MBHP_OPL3 module modifications, the 5V option

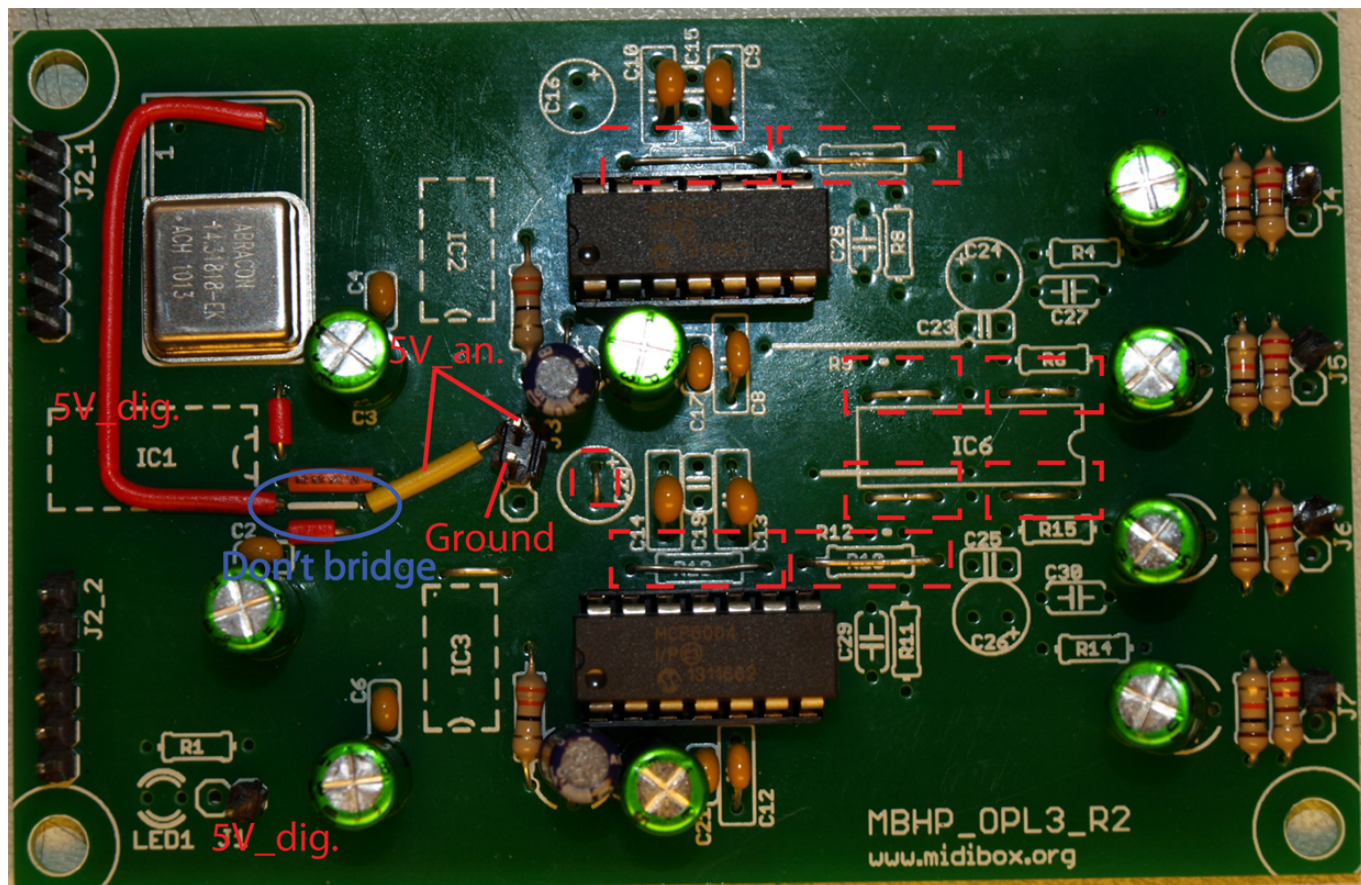
- Replace R5,R7,R10 and R13 with jumpers
- Bridge IC6 pads 1&3, 5&7, 8&10 and 12&14
- Leave out:
IC6
R4, R6, R8, R9, R11, R12, R14, R15
C15, C16, C19, C20, C23-C30
- Bridge C20 pads (to supply Ground for the op-amps)
- Leave out bridges to IC6
- Use MCP6004 for IC3 and IC5
- Supply 5V to the +12V pin, and Ground to Ground

This way the second buffering stage is left out.

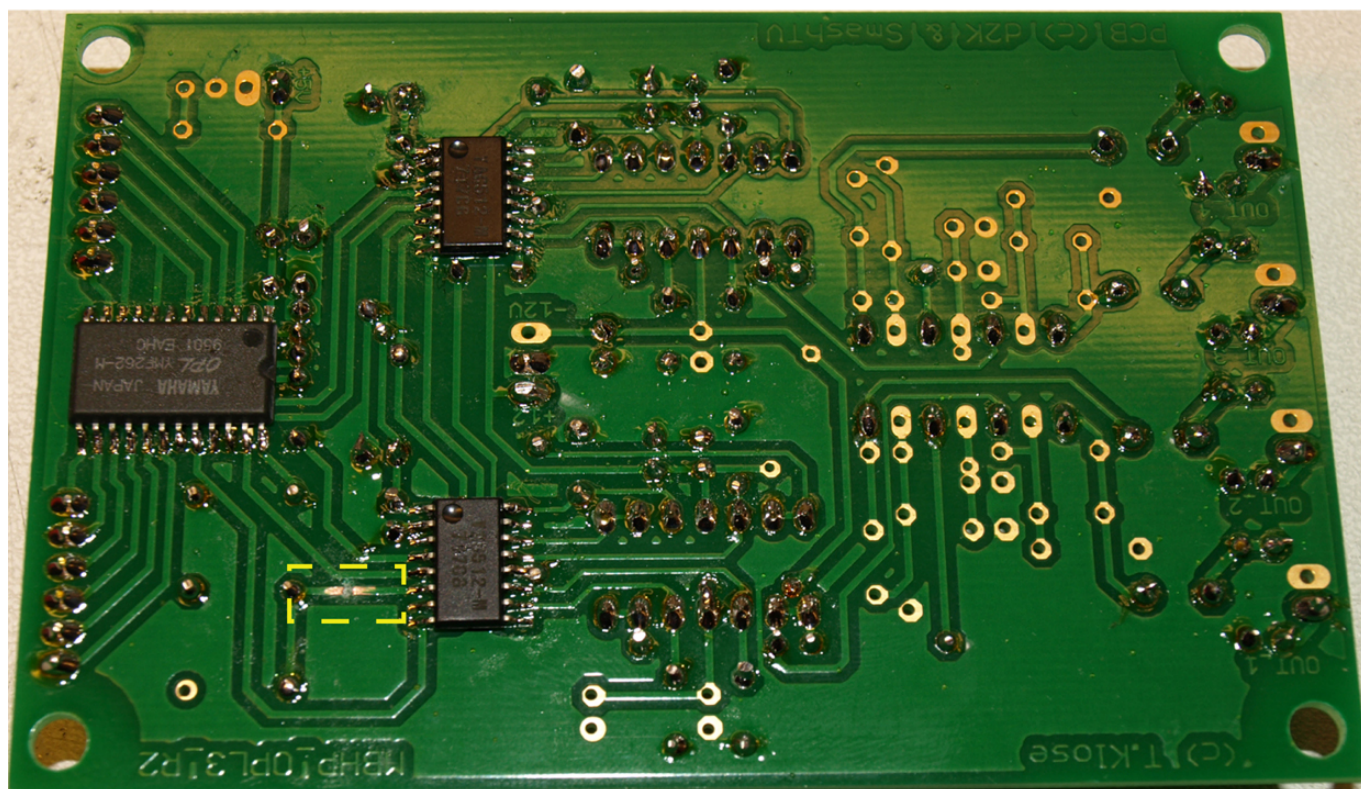
- Cut the trace between the 5V pin of the Oscillator and the DAC
- Leave out the middle horizontal bridge from IC1
- Connect the right pad of this bridge to the 5V pin in the middle of the board with a jumper
- Connect the left pad of this bridge to the 5V pin of the Oscillator with a jumper

Bridge

Cut trace
